Technical BULLETIN

RECALL

2003~2008 GP1300 and 2005~2008 VX1100

FACTORY MODIFICATION CAMPAIGN – Throttle Cable Corrosion

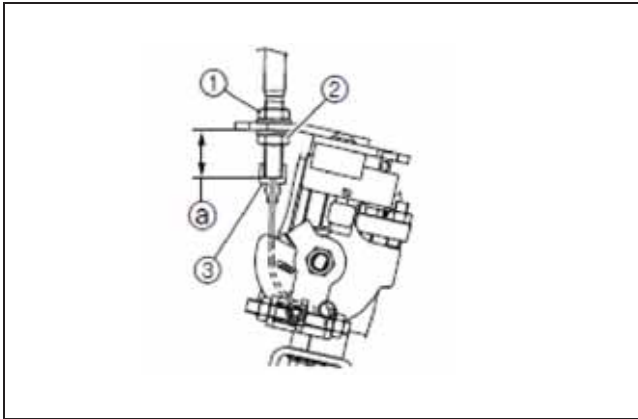
9. Replace the throttle cable with the new throttle cable.

NOTE: Identify the part by its part number.

Previous: 60T5200

New: 60T5201

10. From the inside of the watercraft, insert the throttle cable into the grommet and pull it out to the handlebar side.

11. Apply grease to the throttle cable end, and then temporarily connect the throttle cable to the throttle lever.

12. Replace the sponges of the 2 QSTS cables with new parts and insert the sponges until they are inside the grommet. Install the cables so that their sponge portions are placed 300 mm (11.8 in) from the base of the QSTS grip.

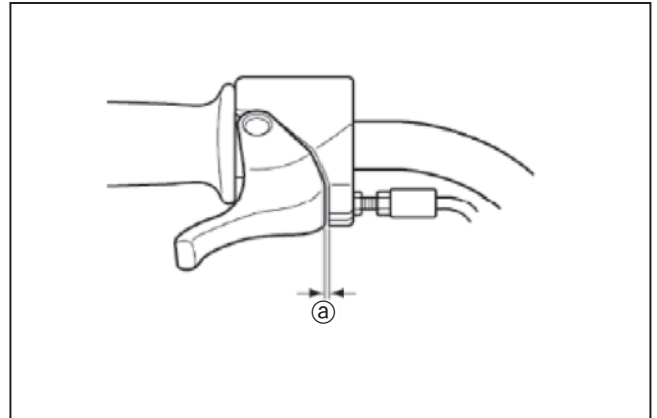
14. Measure the installation length “A” of the throttle cable. Adjust it if this measurement is out of specification. Apply grease to the throttle cable end, then connect the throttle cable to the throttle body assembly. Tighten the throttle cable locknut ① and adjustment nut ② to the specified torque.

Throttle cable installation length “a:”
18.5±1 mm (0.728±0.039 in)

Throttle cable locknut, adjustment nut:
11 Nm (1.1 kgf-m, 8.0 ft-lb)

NOTE: Check that the cover ③ is securely installed.

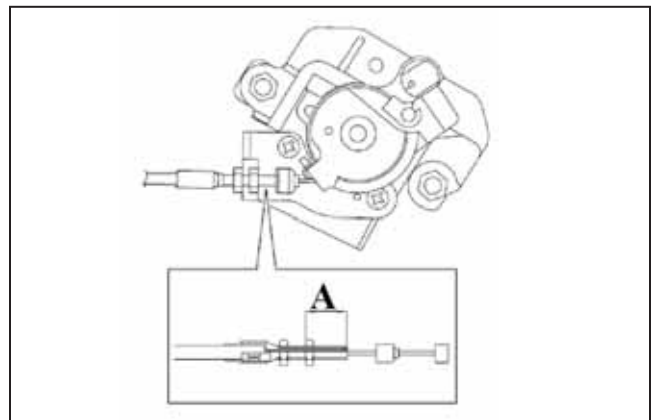
7. Replace the throttle cable with the new throttle cable.

NOTE: Identify the throttle cable by its parts number.

8. Route the throttle cable from the corrugated tube to the steering column.

9. Apply water resistant grease to the throttle cable end. Connect the throttle cable to the accelerator position sensor assembly. Before doing so, measure the installation length "A" of the throttle cable. Adjust it if this measurement is out of specification.

Throttle cable installation length "A":
18.4±1 mm (0.72±0.04 in)

Throttle cable locknut:
6.5 Nm (0.65 kgf-m, 4.7 ft-lb)

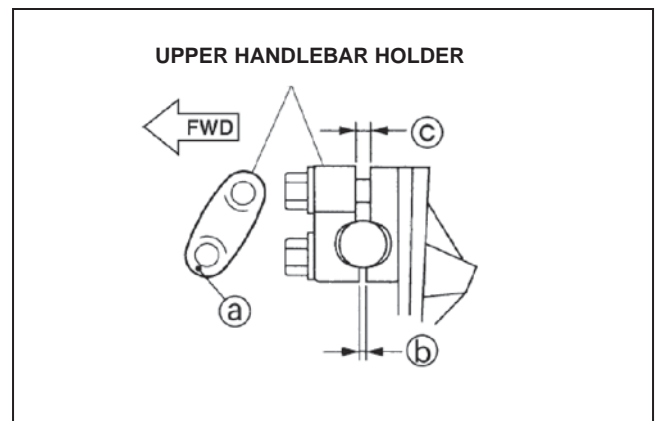
10. Route the throttle cable and the lead for the handlebar switch assembly through the cutout in the new grommet, which is included in the kit. Then, install the grommet in the steering column with its cutout facing starboard side as shown.

Install the new corrugated tube (included in kit) on the throttle cable with its end touching the end face of the grommet.
